SUITE 616-PECONIC BAY

Royal Pine Homes • 25 Water Hill Blvd - Stamford, CT • May 02, 2018

PURCHASER'S EXTRAS (PE)

CONSTRUCTION SUMMARY

SUITE 614
ORIGINAL LAYOUT

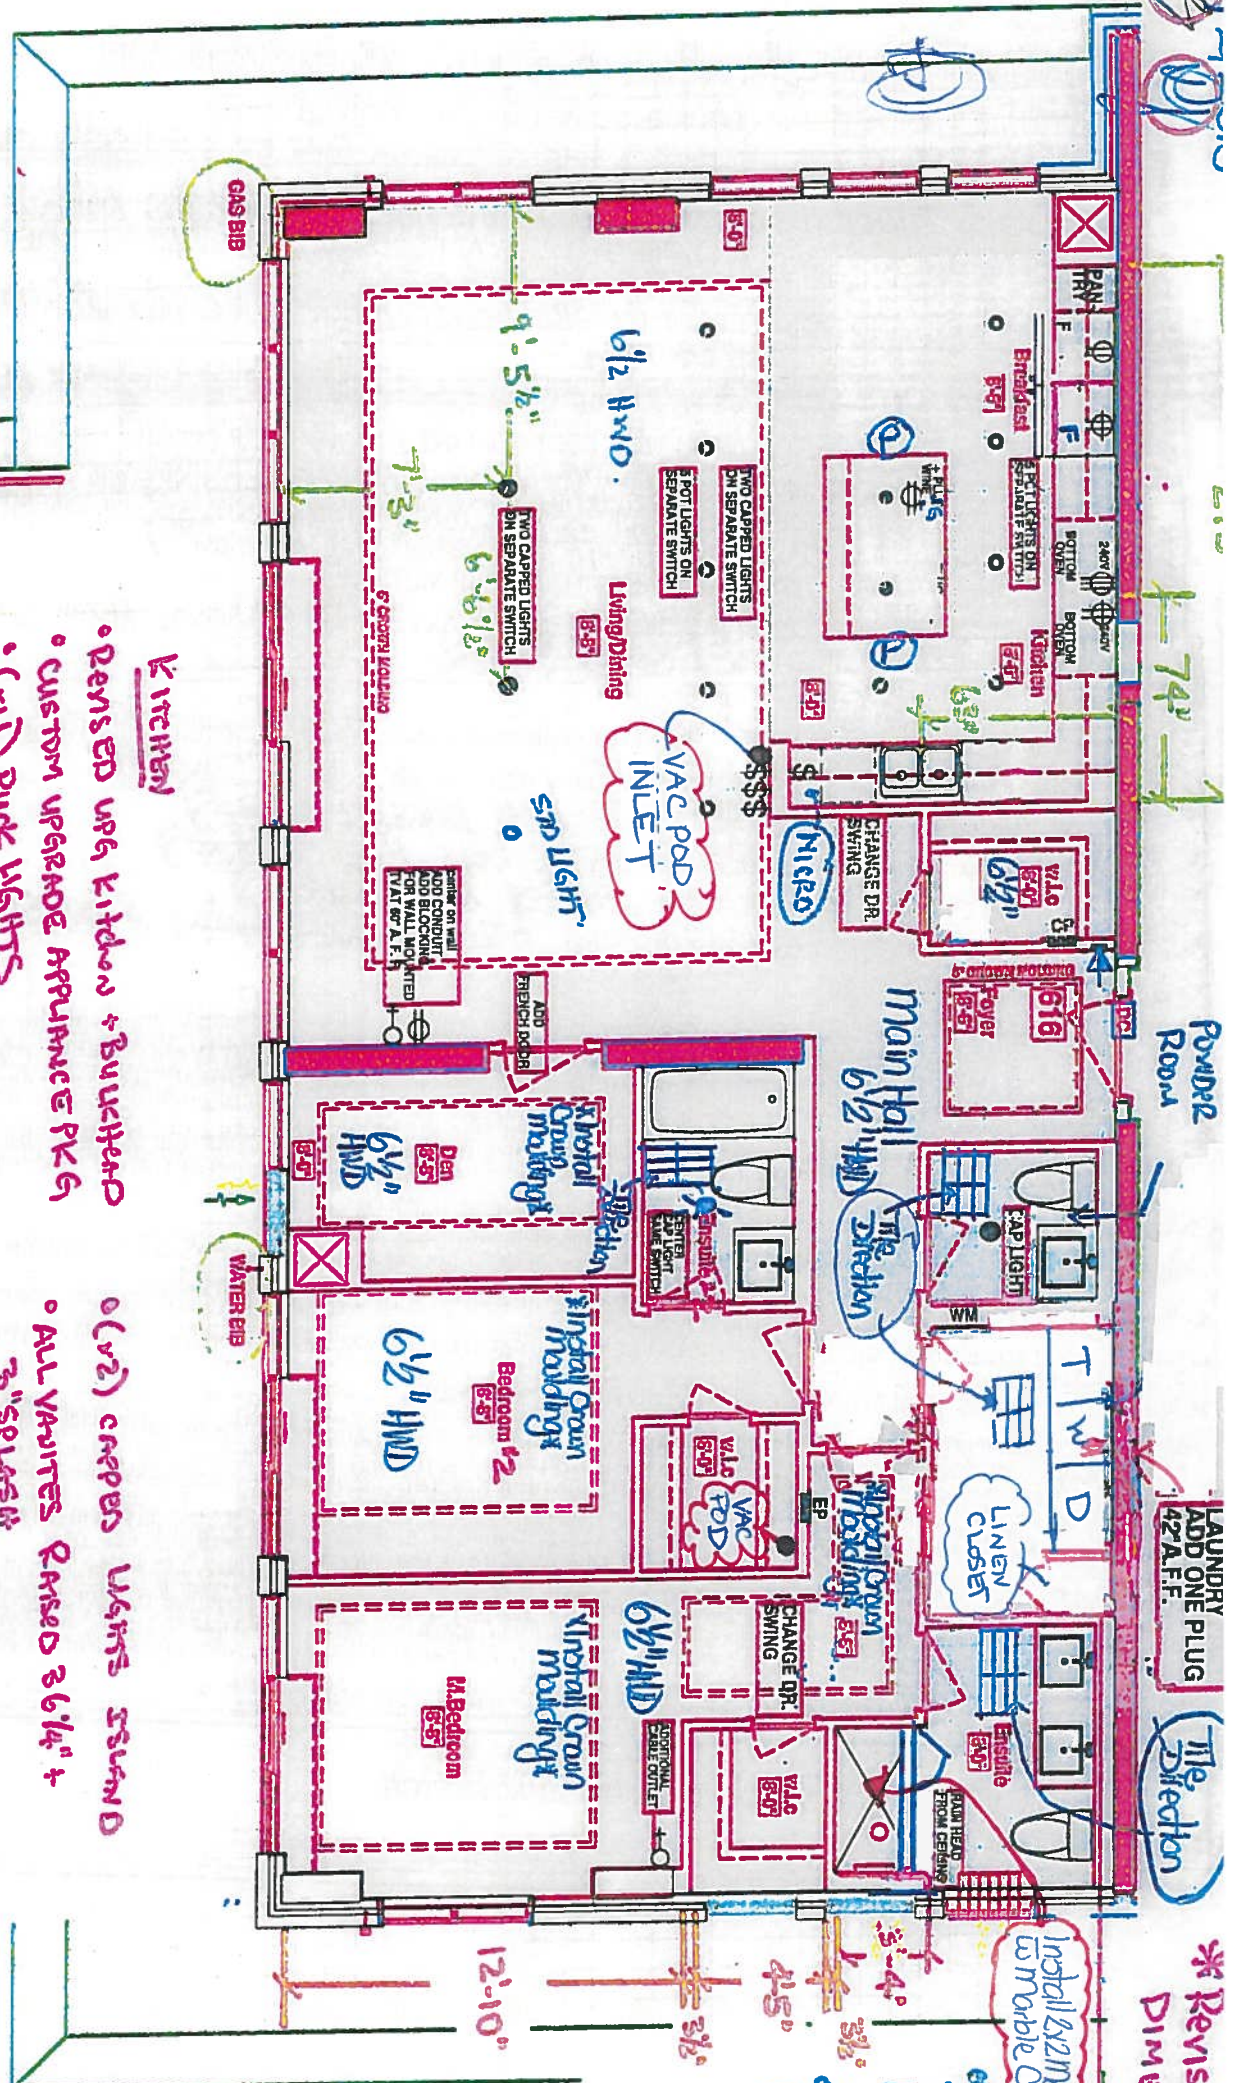
* Revised Laundry closet to DIMENSIONS

LAUNDRY ADD ONE PLUG 42" A.F.F.
Install 2x2 mirrors to marble carb
Delete Ceramic Accents Powder-Rom, Ensuite 2 & Master Ensuite
Delete mirrors, Powder-Rom Ensuite 2 & Master Ensuite

* Revised April 17/19
YAC POD
INSIDE BEDROOM 2 W/C N.T.S.

Master Ensuite: Delete std. shower
Install 2x2 mirrors to marble carb

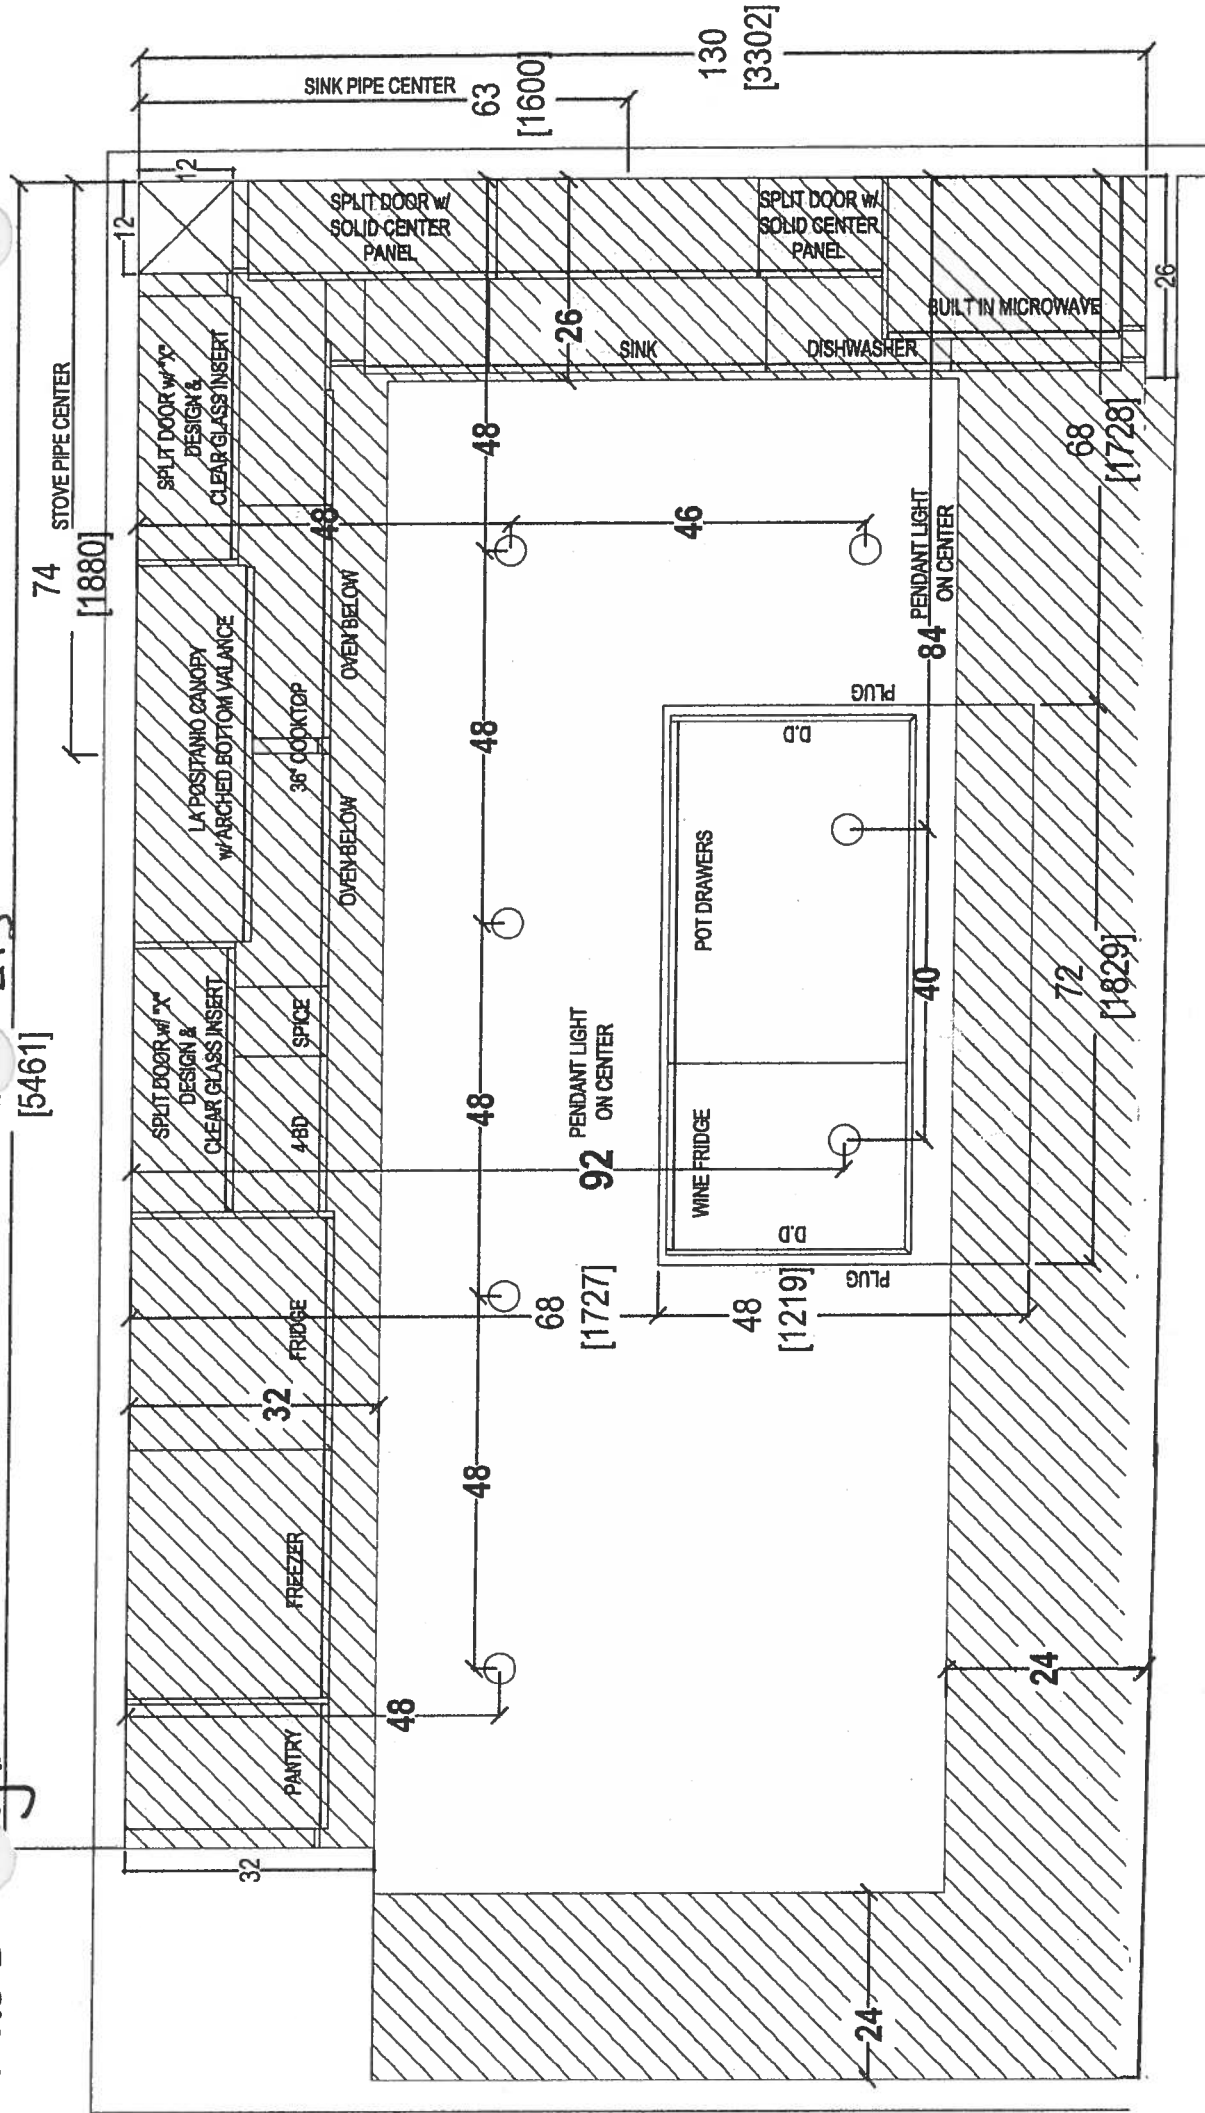
1 - LAUNDRY ROOM- Delete the stackable washer and dryer and install the washer and dryer side by side
Note: As per Fonzie C.

1 - LAUNDRY ROOM- Laundry Room door to swing into the Laundry Room, towards the Powder Room wall. (See Sketch)
Note: As per Fonzie C.

1 - MASTER BEDROOM / LAUNDRY ROOM- Delete the Linen closet in the master Bedroom and reloacte it into the Laundry Room, next to the dryer (As per the sketch attached)
Note:

1 - BEDROOM #2- Relocate the VAC POD from original location into Bedroom #2 Walk In Closet

Relocate the additional VAC POD inlet in the Living Room (As Per Sketch)
Note: As per Fonzie C.

1 - LAUNDRY ROOM - laundry room vanity to be reduced from approx. 44" wide to new size of approx. 32" wide. Laundry vanity to be relocated against wall as per sketch. (Delete Laundry Matte Box All Connections now Below Cabinet)
Note: As per Fonzie C.

1 - REFER TO APAS;
DELETE - ENSUITE #2 - Install Capped Ceiling Light and Fixture at Ensuite #2 (See Sketch)
Note: As per Fonzie

1 - INSTALL;
ENSUITE #2 - Install ONE (1) Shower Pot Light with Seperate Switch at Ensuite #2 Tub/Shower Enclosure (See Sketch)
Note: As per Fonzie C.

Suite 616 Hampton
 Revised - Laundry
 May 1, 2019

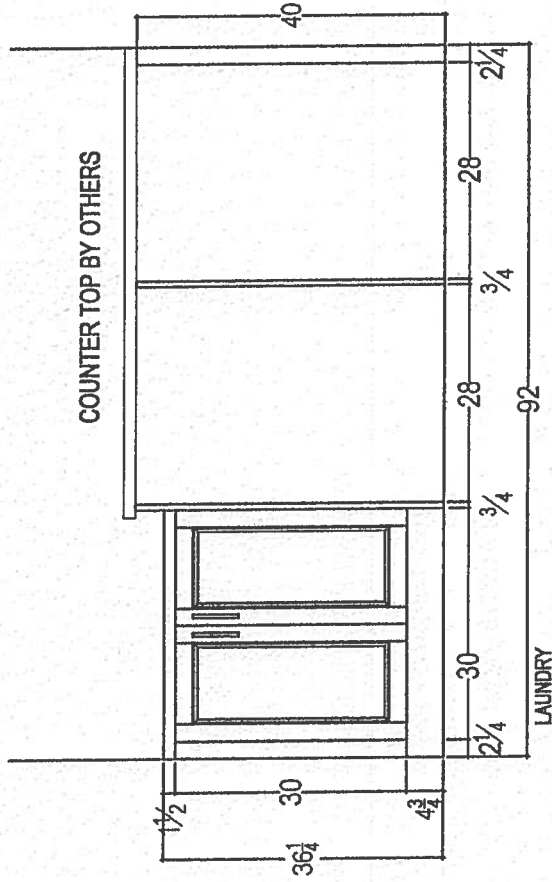
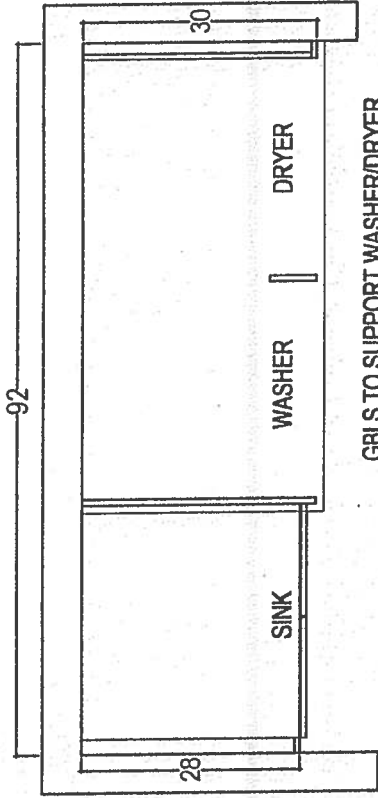
1 - LAUNDRY ROOM - Laundry Cabinet prepared for Raised Granite (See Attahced for Revised QTK Layout)
Note: As per Fonzie C.

1 - LAUNDRY ROOM - Install Standard Stone Countertop - ASPEN CYRUS GREY - To accommodate raised revised laundry cabinet and countertop above washer and dryer area. (See Attached Sketch)
Note: As per Fonzie C.

Master Ensuite
Shower Stall

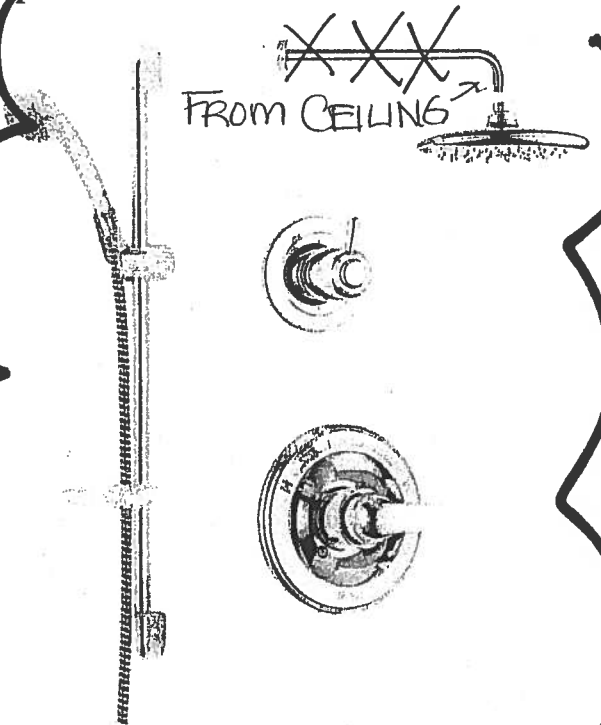
Delta Shower Trim with ~~Tub Spout~~ and
Hansgrohe Slide Bar with Handheld and
Ceiling ~~Mount~~ Showerhead
#R10000/T13020-CDN/27454002/
27744000/RP52382/RP46870/RP6025/
R11000/T11800
